AGENDA
Planning and Zoning Commission
June 4, 2025 – REGULAR MEETING
5:30 PM

- I. Items P25-007 & P25-046: 50 S. Millward Street
Sketch Plan and Conditional Use Permit

Meeting Date:	June 4, 2025	Meeting Title:	Planning Commission
Submitting Department:	Planning Department	Presenter:	Katelyn Page
Agenda Item:	P25-007 and P25-046: Sketch Plan and Conditional Use Permit for a 3-story mixed use development at 50 S. Millward Street	Public Comment:	Yes

FLOOR PLAN - LEVEL 1

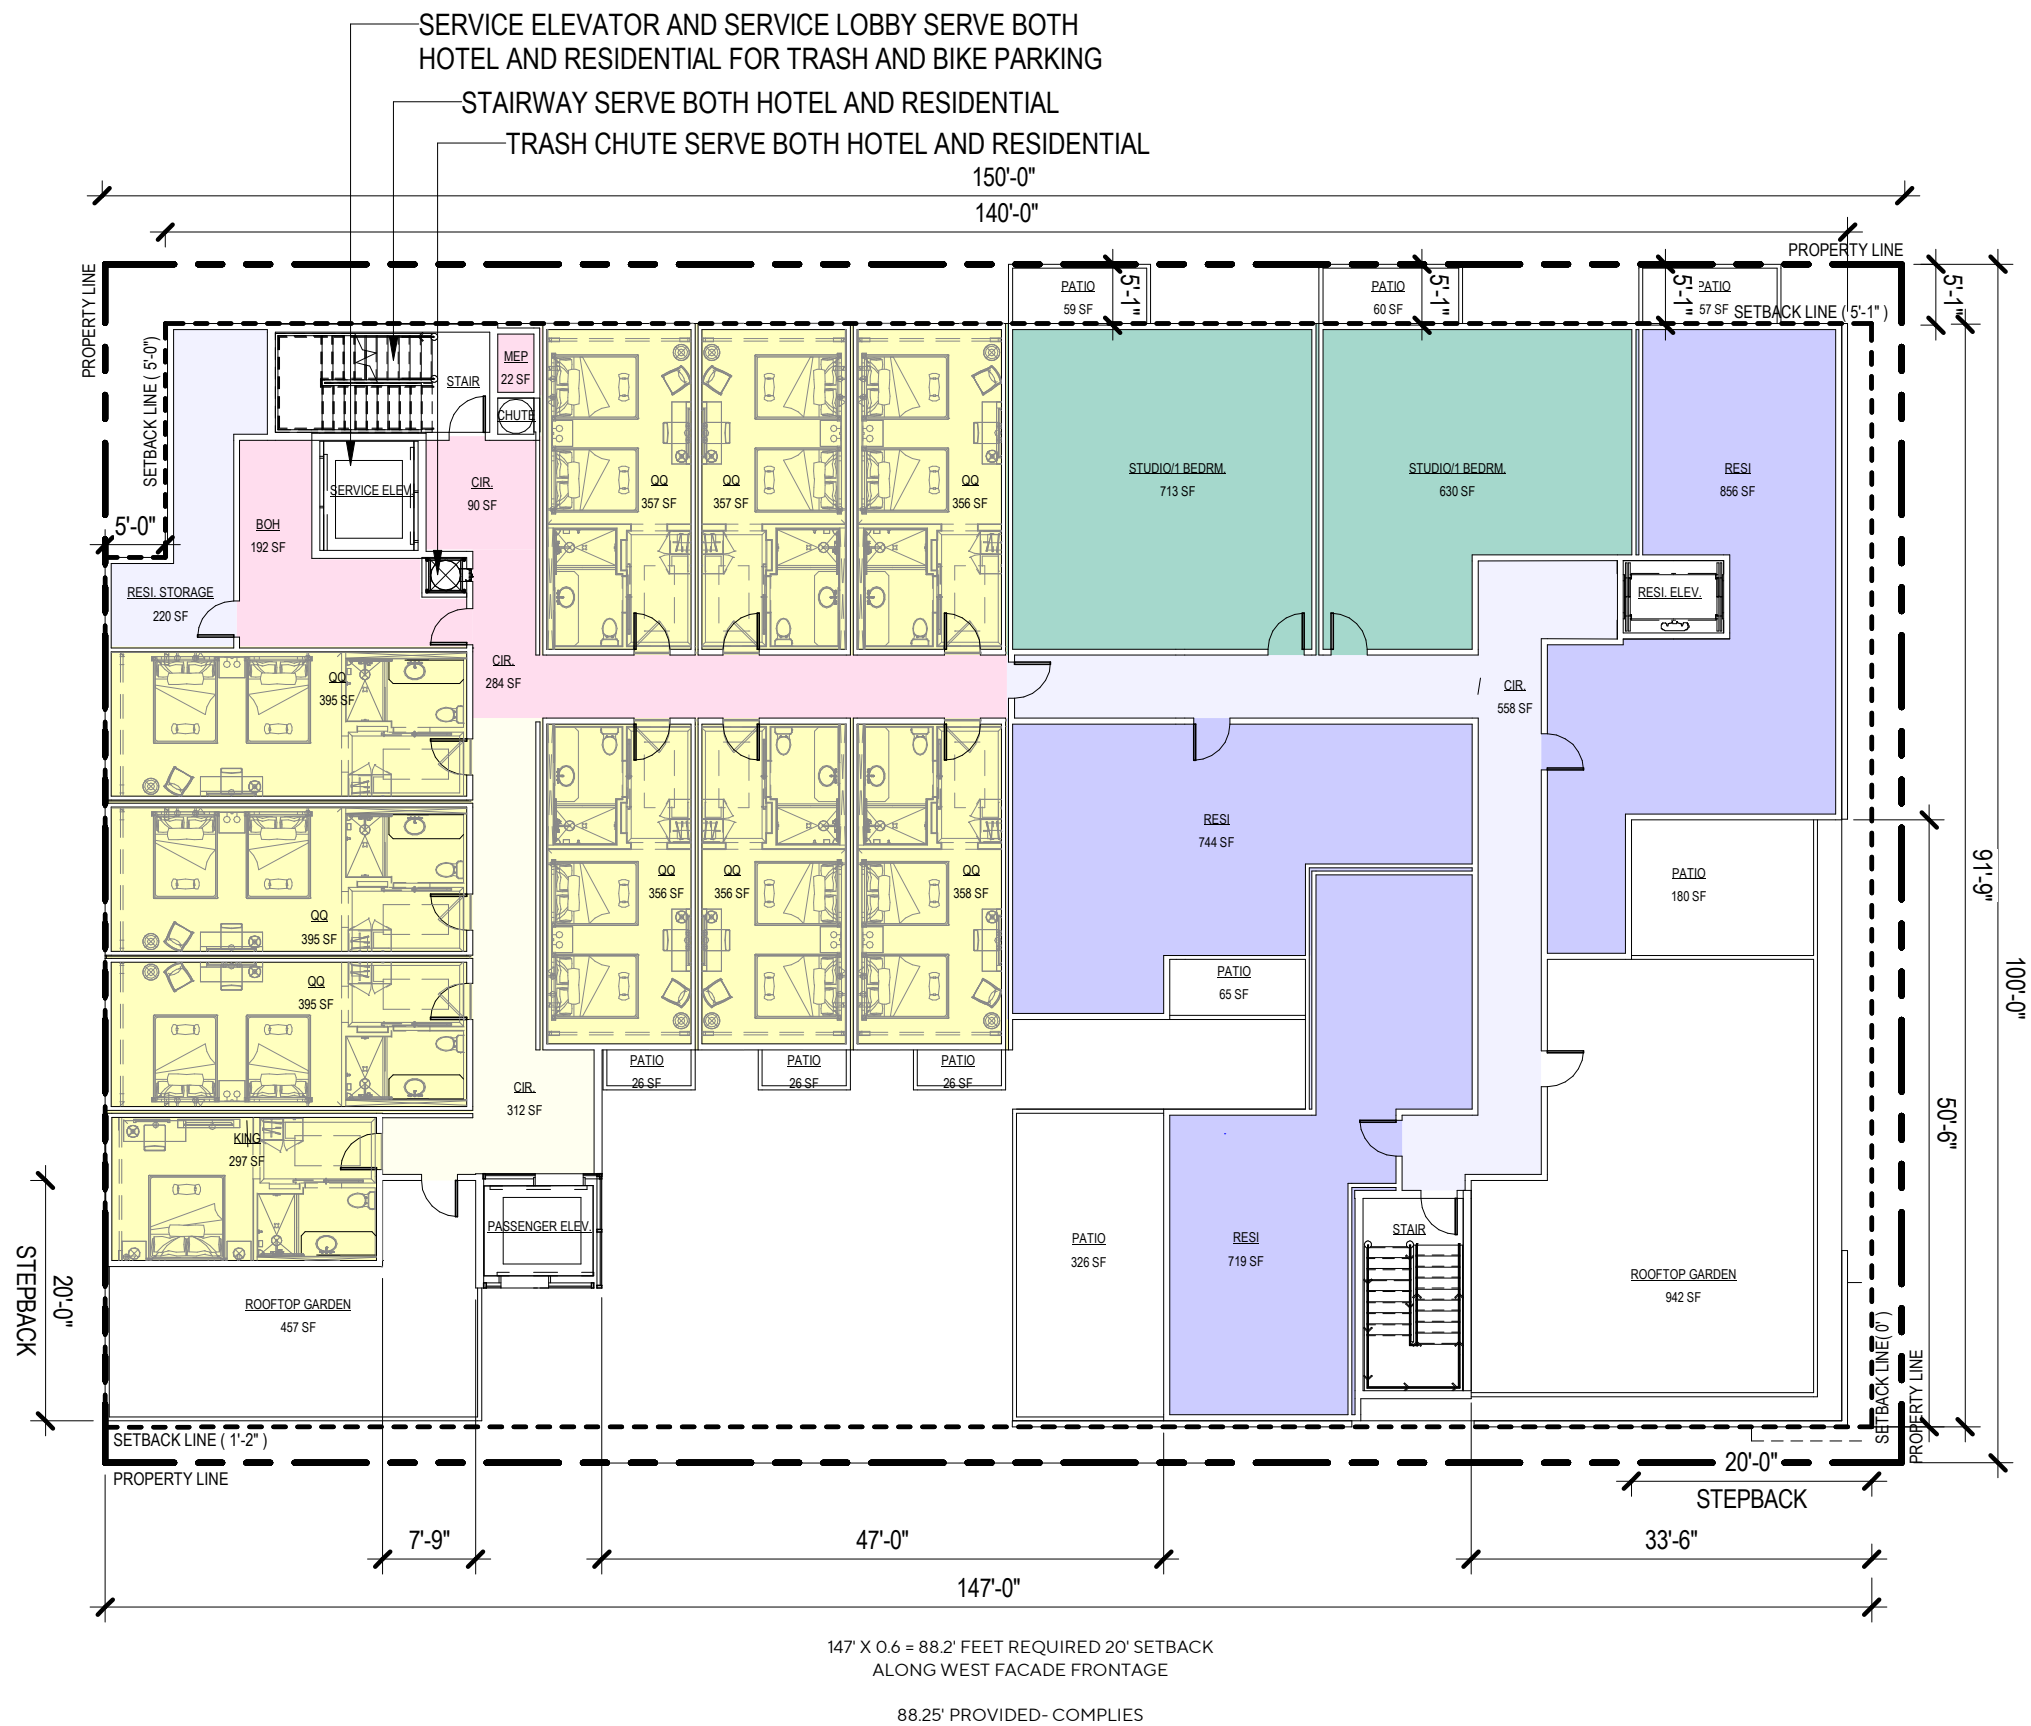
Sheet 11, Floor Plan Street Level:		
		28. Set the parking spaces on Millward back from alley entrance.	Noted.	See civil site plan
		Sheet 16, North and South Buildings Section 1-1:

NORTH AND SOUTH BUILDINGS - SECTION 1-1

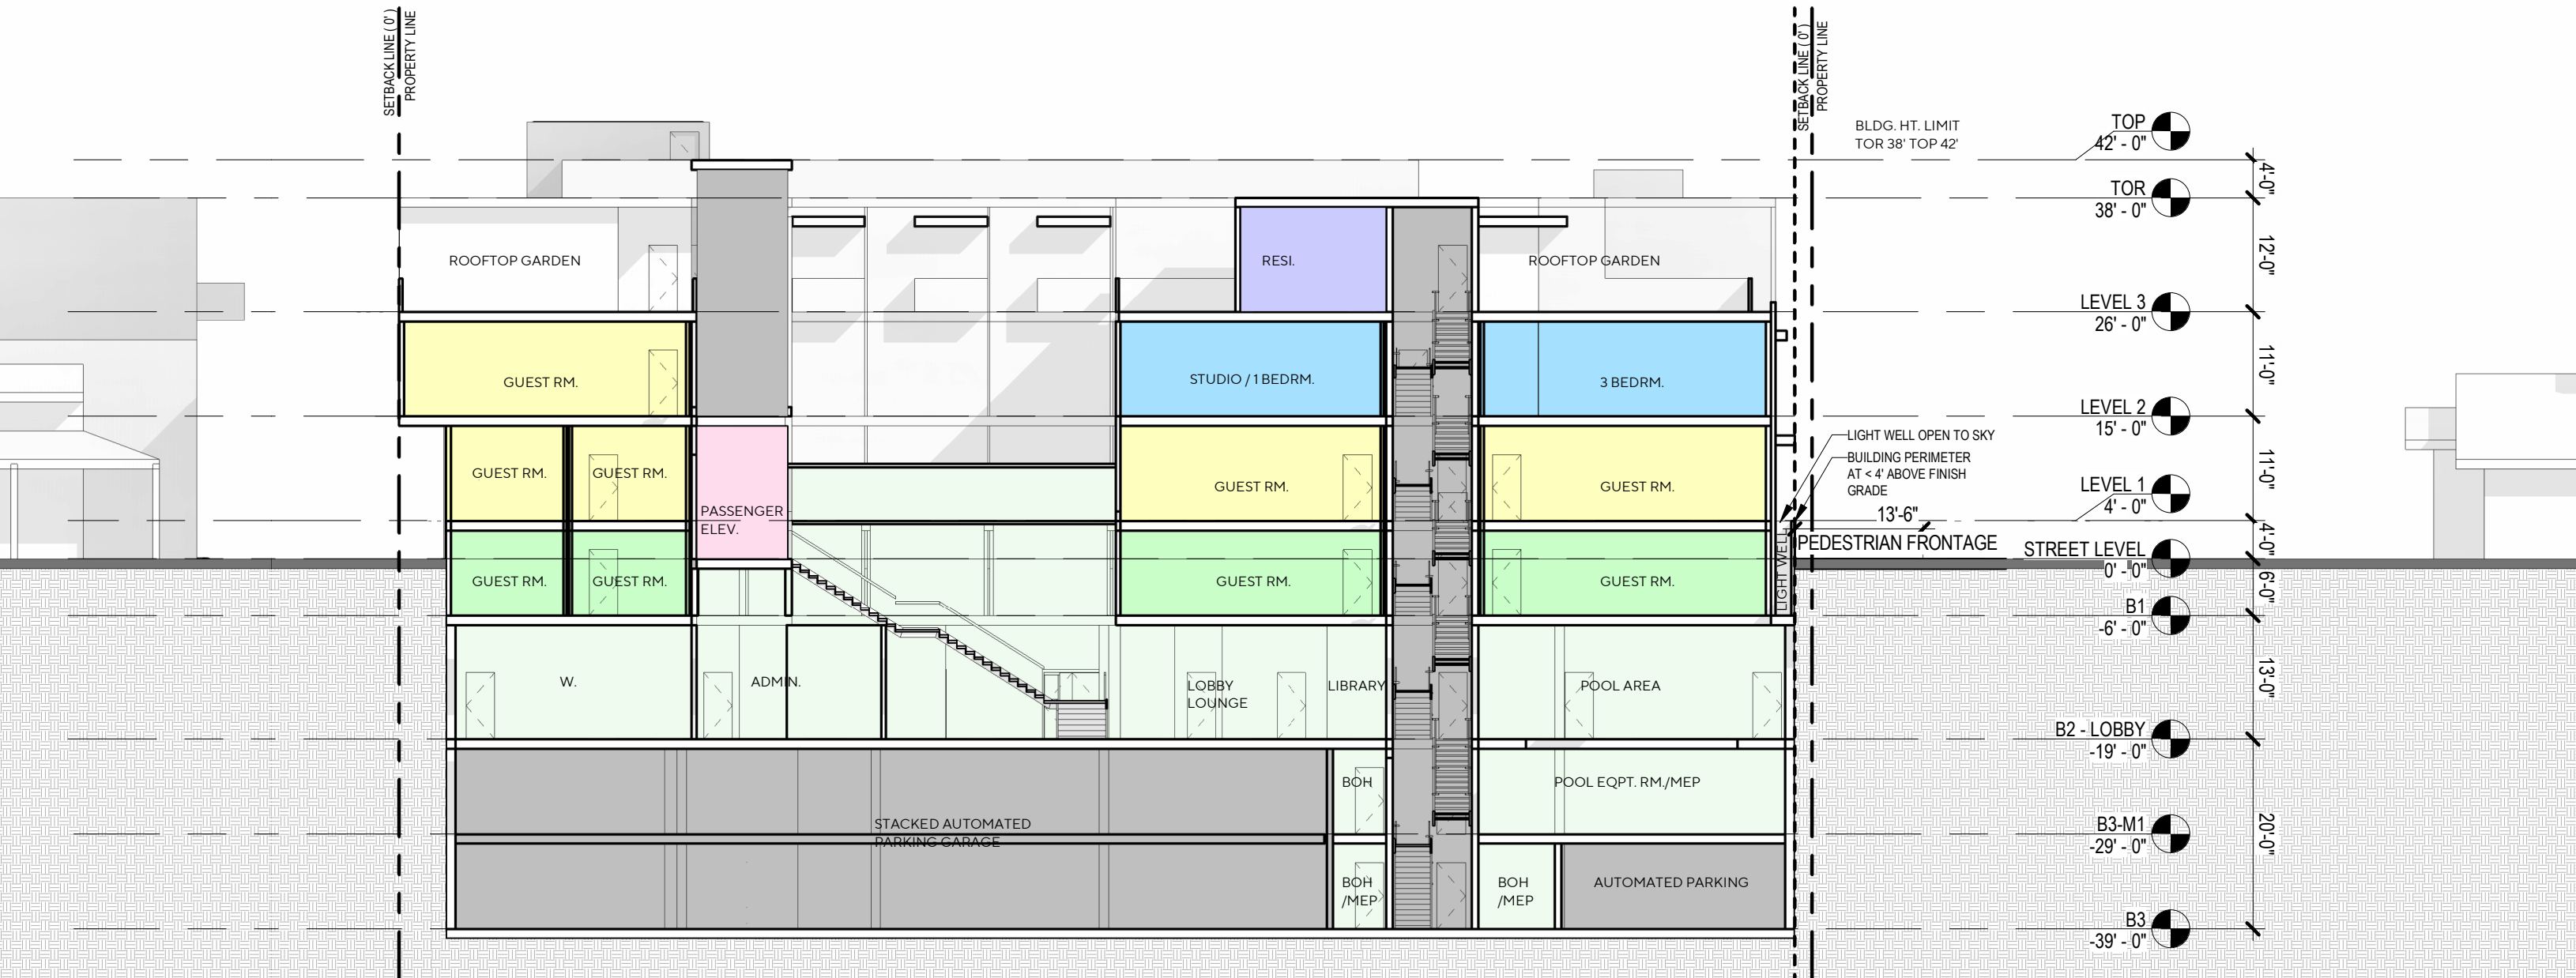
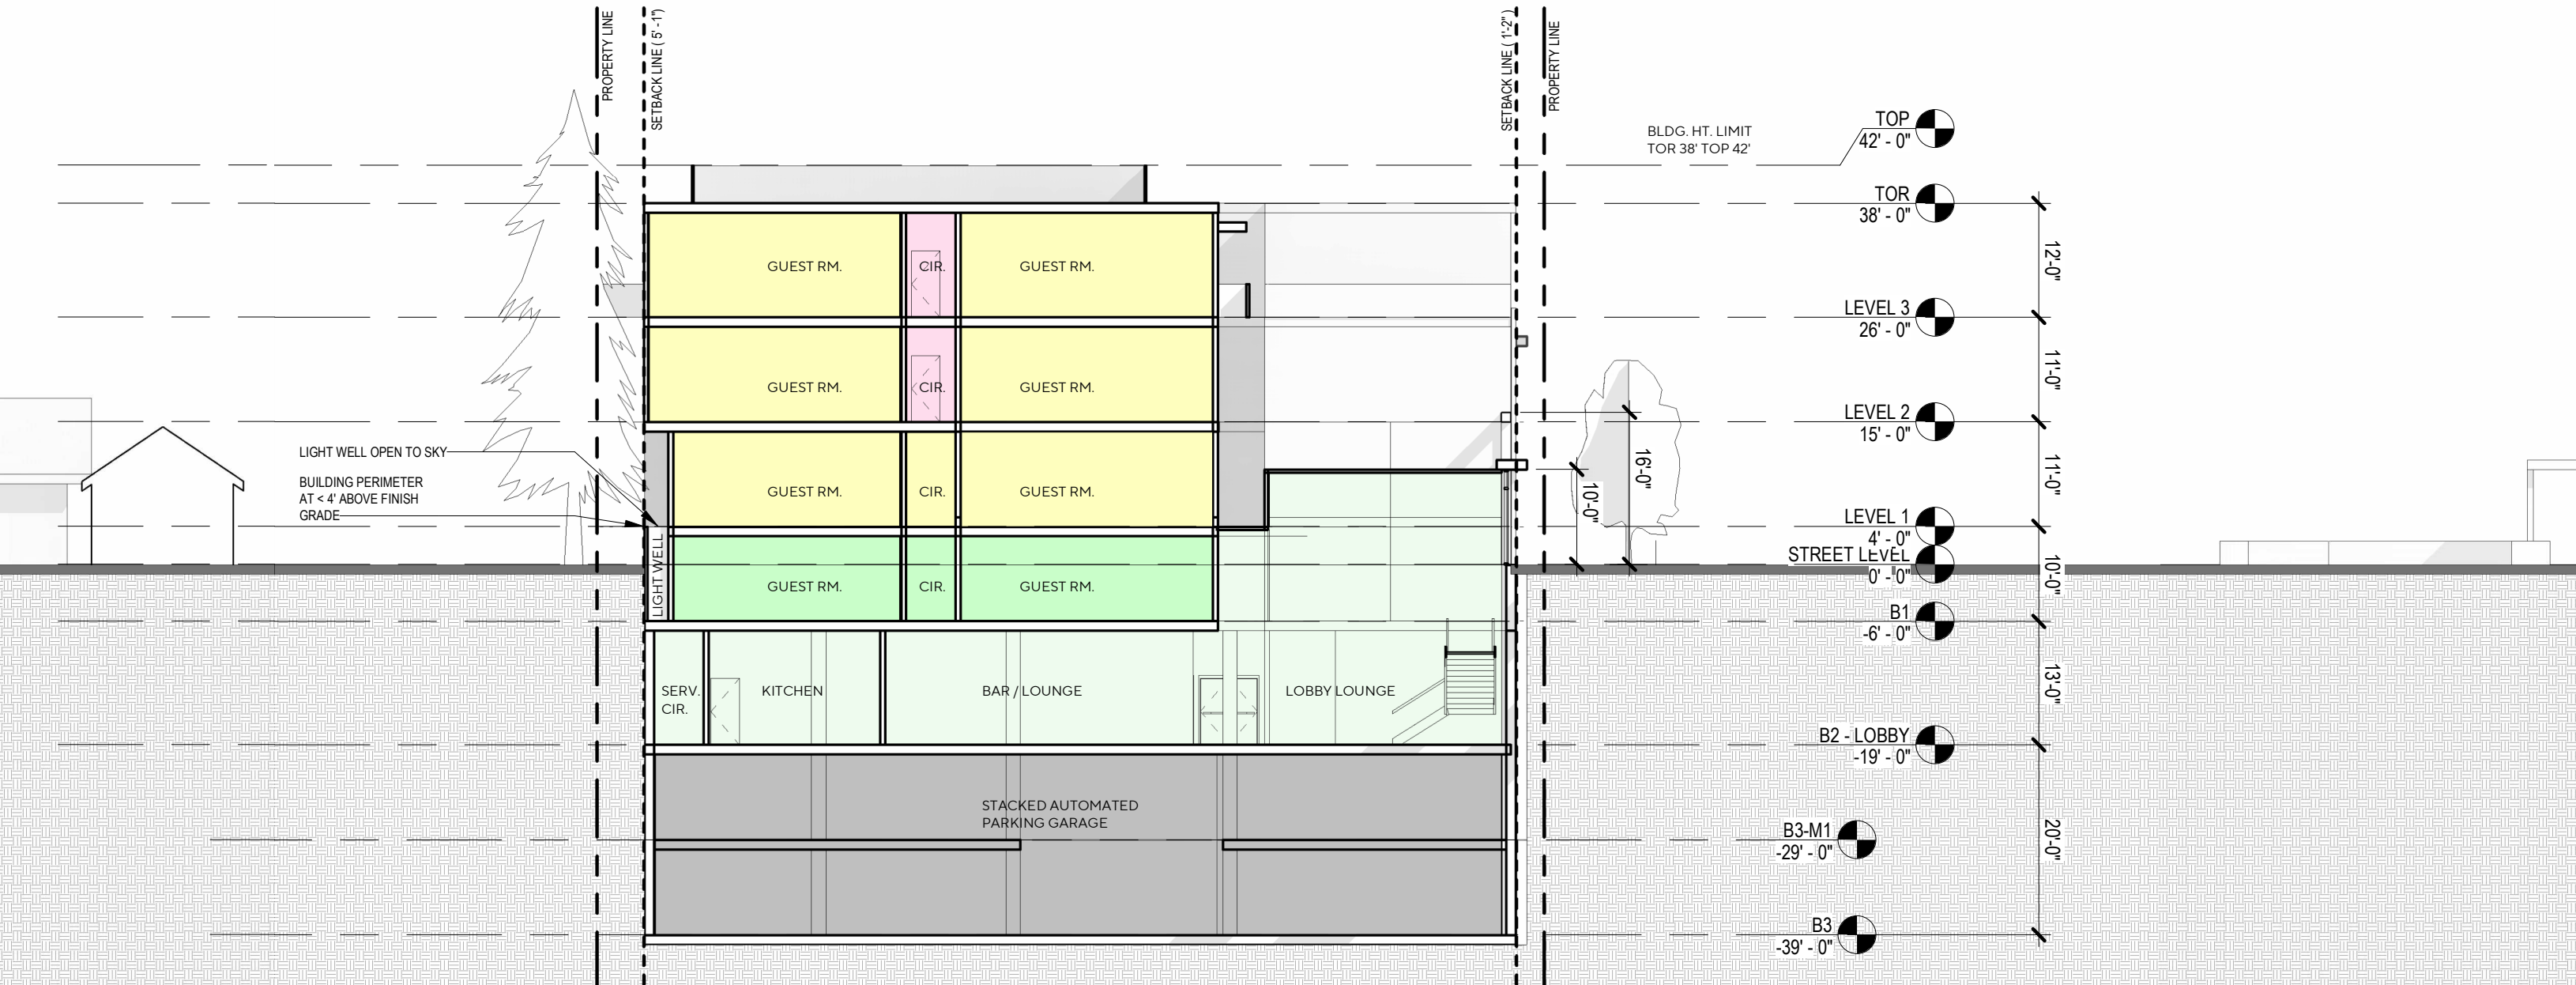
Street Faade width % - It appears that the building does not meet required 2nd story street faade width in primary street setback range if Millward is considered the primary street for this form based standard. Based on cross section provided on Arch. Plansheet sheet 17, and
